Appendix F: Pre-PIC Correspondence

Re: Notice of Completion of Class Environmental Assessment Study Bayshore Village Effluent Spray Irrigation System – LSRCA Comments

Re: Township of Ramara Bayshore Village Sewage Works Effluent Spray Irrigation Class EA Response to Comments

RE: Bayshore Village Sewage Works Effluent Spray Irrigation Township of Ramara Class Environmental Assessment Final Project File, September 26, 2017

Bayshore Village Subdivision Well Supply Wellhead Protection Areas

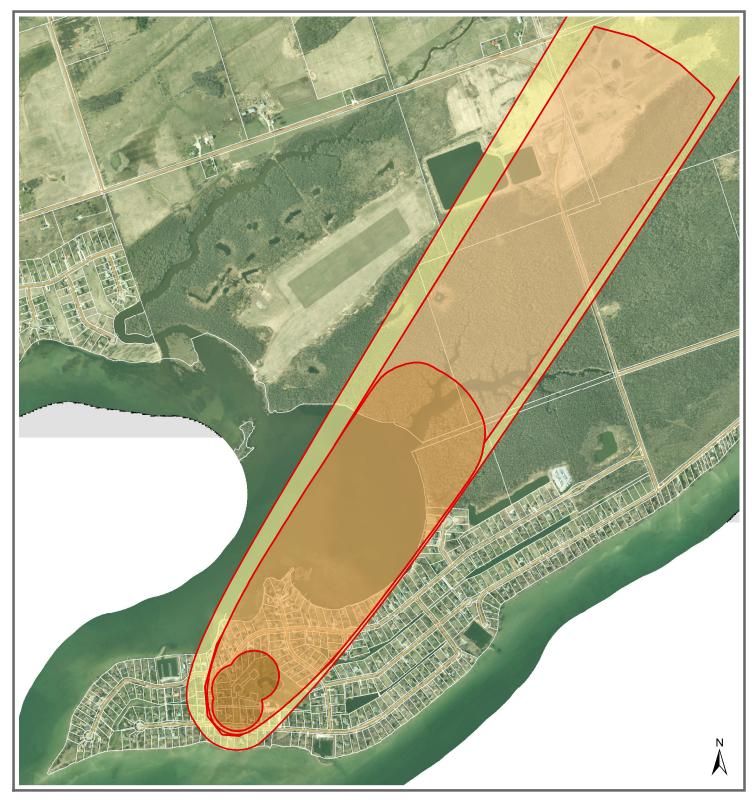
The establishment, operation or maintenance of a system that collects, stores, transmits, treats or disposes of sewage is one of the prescribed drinking water threats under the *Clean Water Act, 2006*. A portion of the south effluent spray irrigation field is within the wellhead protection area for the Bayshore Village Subdivision Well Supply (see Appendix A). Policies SEWG(b)-1 to SEWG(b)-3 of the South Georgian Bay Lake Simcoe Source Protection Plan and the circumstances and vulnerability score needed for the effluent discharge to be considered a significant drinking water threat should be reviewed to ensure that the proposed activity will be permitted. The recommended short term solution of establishing an additional spray irrigation field (Alternative 3A from the abovementioned report) adjacent to the existing field should be scrutinized in the same way.

During the Class EA study, we reviewed the South Georgian Bay Lake Simcoe Source Protection Plan and table of circumstances leading to a significant threat, and how these may affect the alternative approaches to resolving the issues with the Bayshore Village effluent spray irrigation system. Part of the existing sewage lagoons and effluent spray irrigation fields are within the WHPA-C (5-year time of travel) or WHPA-D (25-year time of travel) for the Bayshore Village municipal wells.

The existing sewage lagoons and spray irrigation system are approved by an MOE Certificate of Approval. The C of A includes terms and conditions and monitoring requirements, which are consistently met by the Township of Ramara. Therefore, Policy SEWG(b)-1 does not apply and Policy SEWG(b)-2 is met. Further, as a small sewage treatment plant discharging less than 400 m³/day of treated effluent, the Bayshore Village facility is not considered a significant threat to the municipal drinking water supply.

Some of the additional effluent spray irrigation areas adjacent to the lagoons that were suggested in the Class EA study would be within the WHPA-C or D and others would be outside the wellhead protection areas. It is acknowledged that it would be preferable for any new effluent spray irrigation field to be located outside of the wellhead protection area. We note however that the activity would not be a significant threat (due to the small volume of effluent applied) and that any ECA amendment that will be issued approving additional effluent spray fields would contain terms and conditions to ensure the new works are built, operated and monitored such that they do not become a significant threat to the

Bayshore Village well supply. Therefore, Policy SEWG(b)-3 does not apply under the circumstances at this site.
